**ANGELO'S AGGREGATE MATERIALS  
ENTERPRISE RECYCLING AND DISPOSAL FACILITY  
CLASS III OPERATIONS PERMIT MINOR  
MODIFICATIONS—UPDATES**

Revised  
10/22/09  
11/23/09

Re: Angelo's Recycled Materials Class III Landfill and Recycling Facility  
Permit Application Modification #177982-016-SO/MM to Existing  
Operation Permit #177982-007-SO-T3 and #177982-017-SC/MM to Existing  
Construction Permit #177982-008-SC/T3  
Response to FDEP Request for Additional Information  
Jones Edmunds Project No. 95380-436-09

This letter has been prepared in response to the request for additional information (RAI) prepared by the Florida Department of Environmental Protection (Southwest District Office), dated September 4, 2009. Each of the Department's comments is presented below in *italics*, followed by the response in **bold type**.

FIGURE 3-13  
GAS MONITORING PROBE LOCATION MAP  
ENTERPRISE RECYCLING  
AND DISPOSAL FACILITY  
PASCO COUNTY, FLORIDA

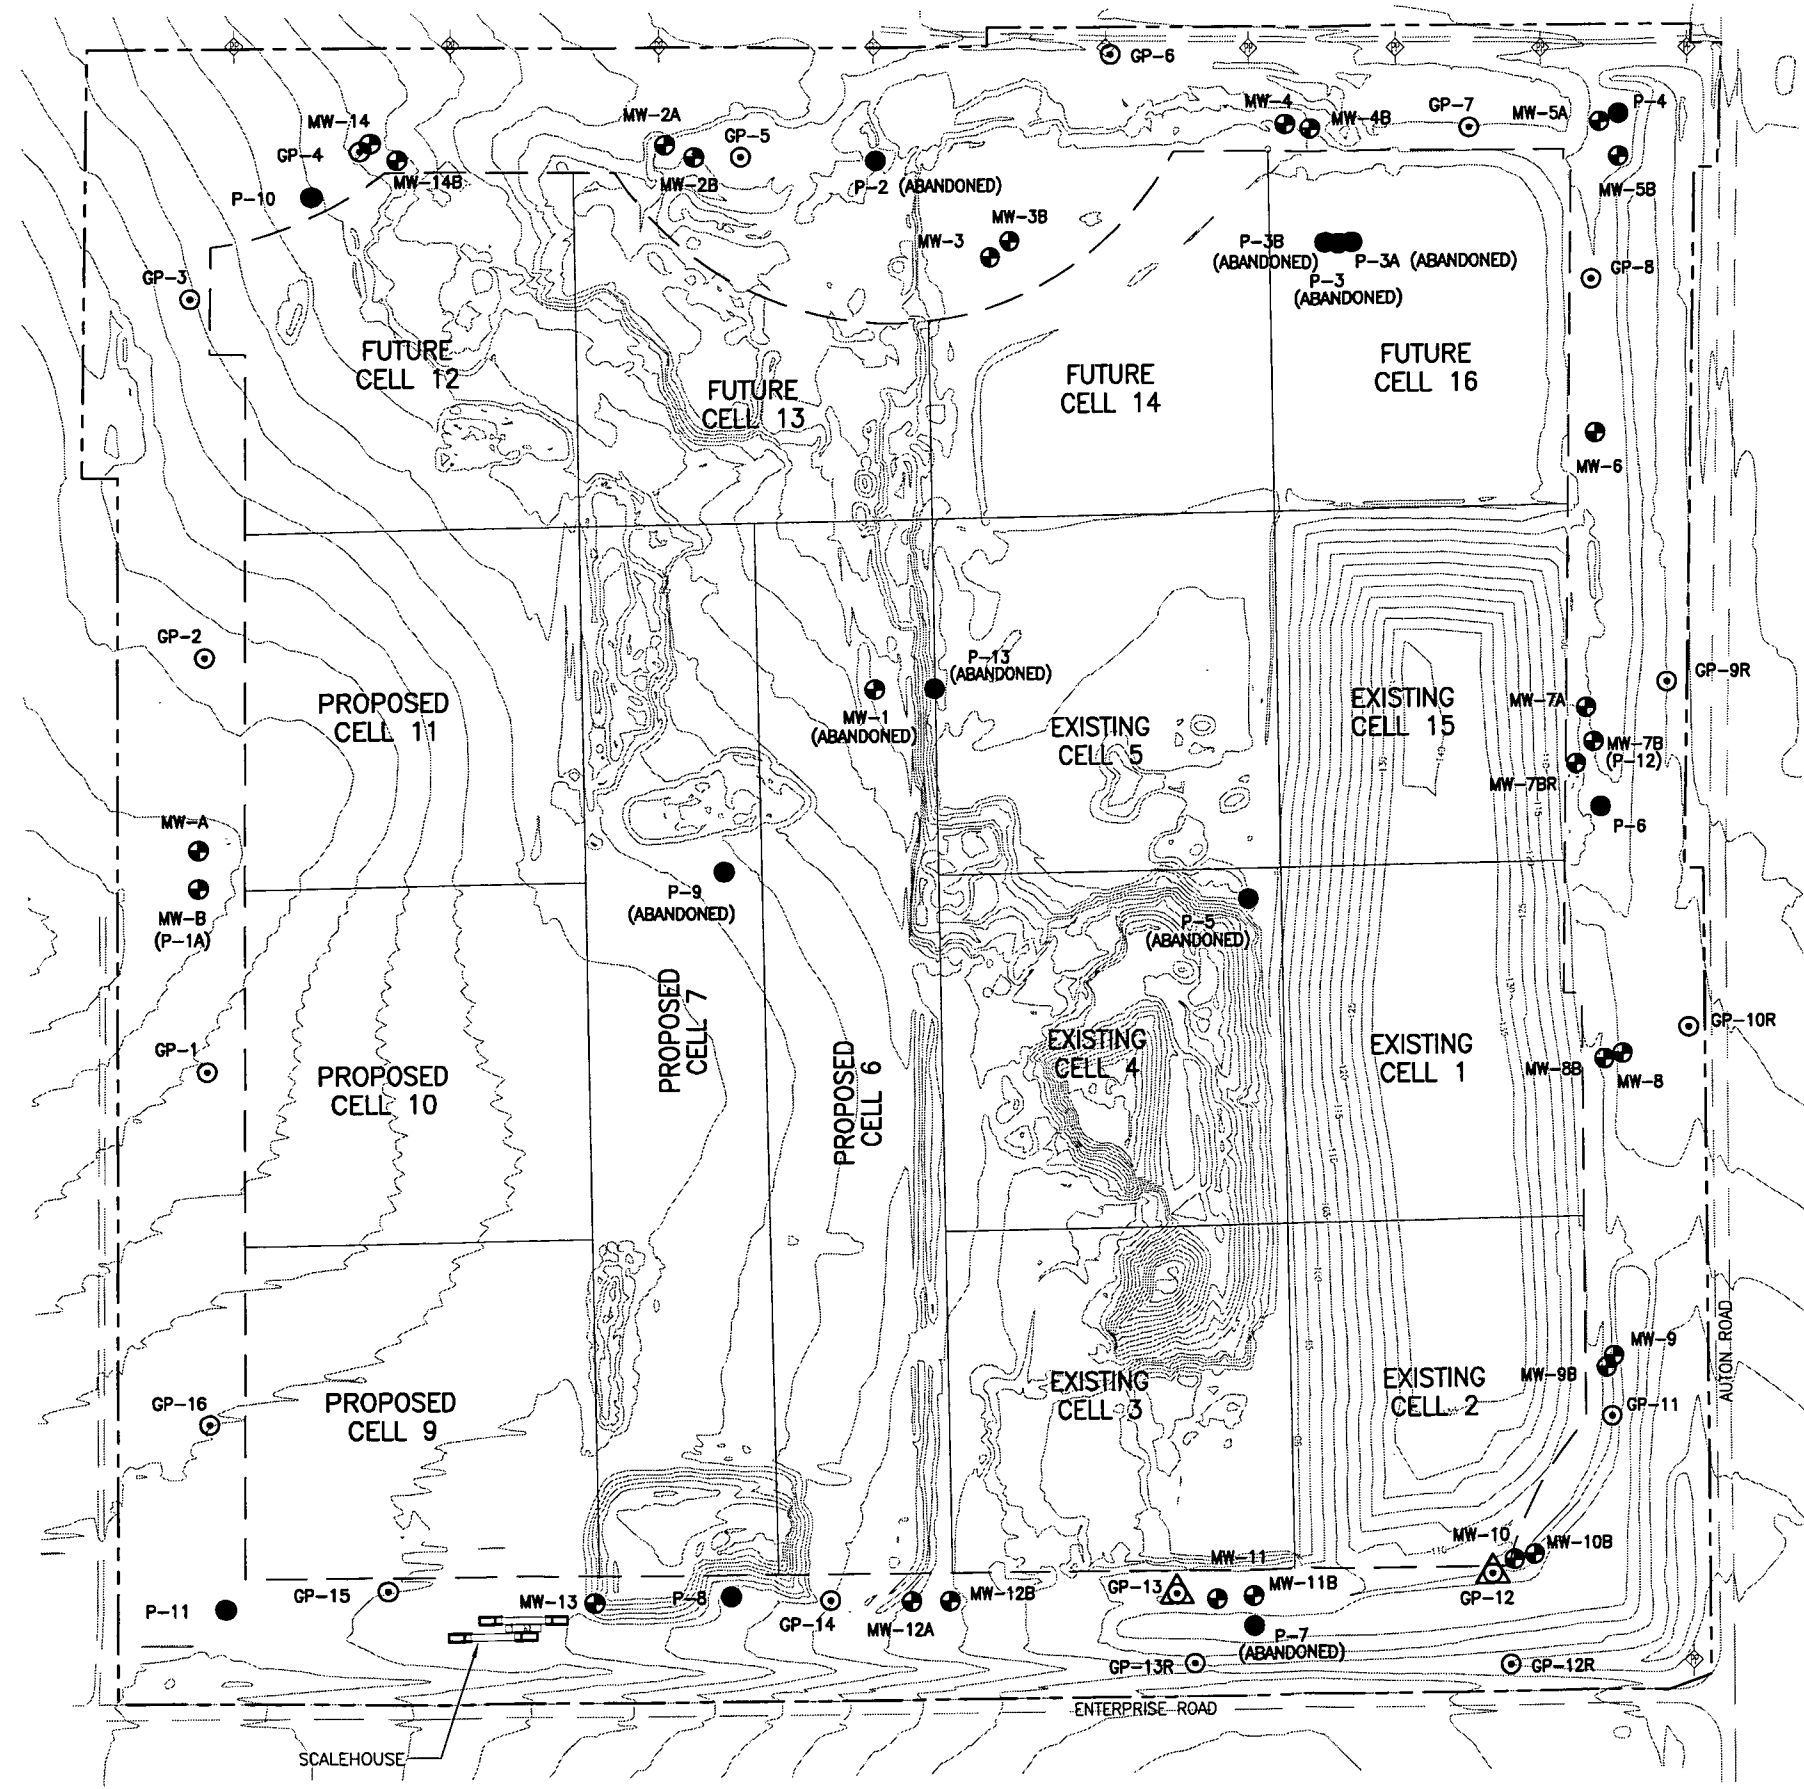
- a. Please revise Section 3.10 of the Engineering Report, where applicable, to include the proposed additional gas monitoring probe in the facility's gas monitoring plan and on applicable figures (e.g. Figures 3-13 and 3-15).*

**Response 5.a: Figures 3-13 and 3-15 have been revised to include the recently installed gas monitoring probes GP-12R and GP-13R. Since these figures were originally generated by HAI, Jones Edmunds re-created these figures and made the appropriate updates. Please see the revised figures contained in Attachment 5.a.1. Please also note that the gas probes have been included in the new Figure 15A (Attachment 3).**

**ATTACHMENT 7**  
**REVISED DRAWING C-5**

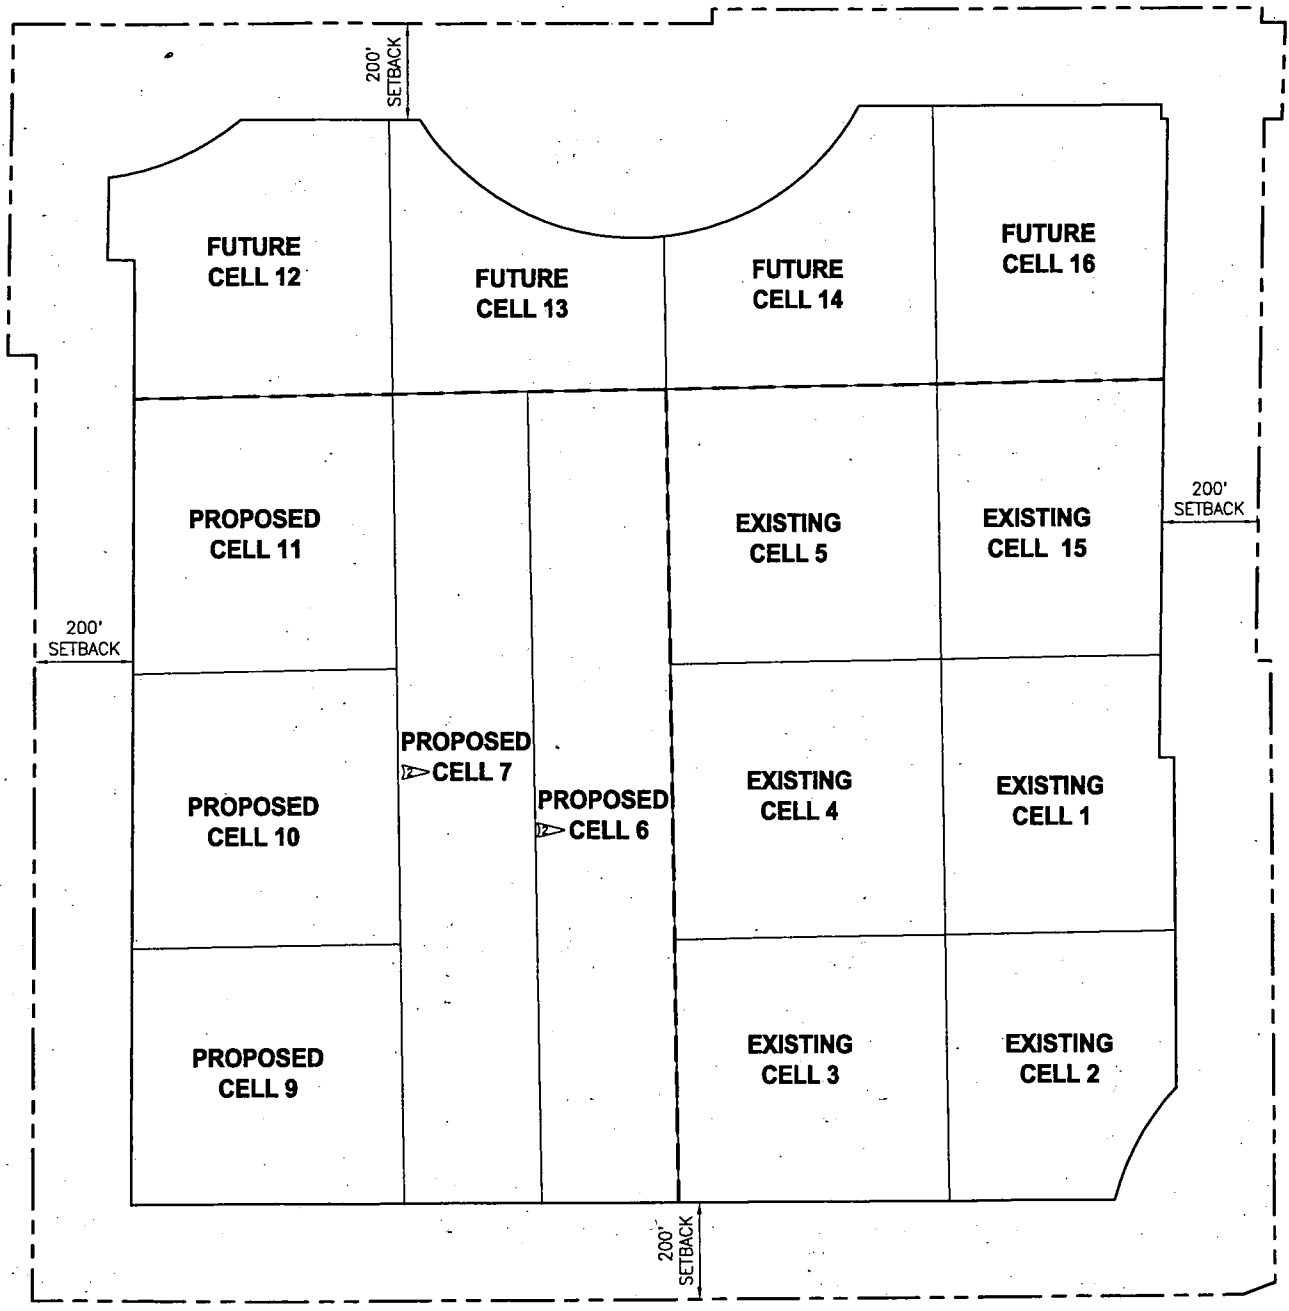
- a. *Sheet C-5: The revised sequence of fill narrative in Section 3.8 of the Operation Plan indicates that Cells 6 and 7 will also be filled during Fill Sequence 8. Please verify and revise the Excavation, Construction and Filling Sequence table on this sheet, as appropriate.*

**Response 7.a: The Excavation, Construction and Filling Sequence table on Sheet C-5 has been revised to match the sequence of fill narrative in Section 3.8 of the Operation Plan. Please see the revised drawing included in Attachment 7.**
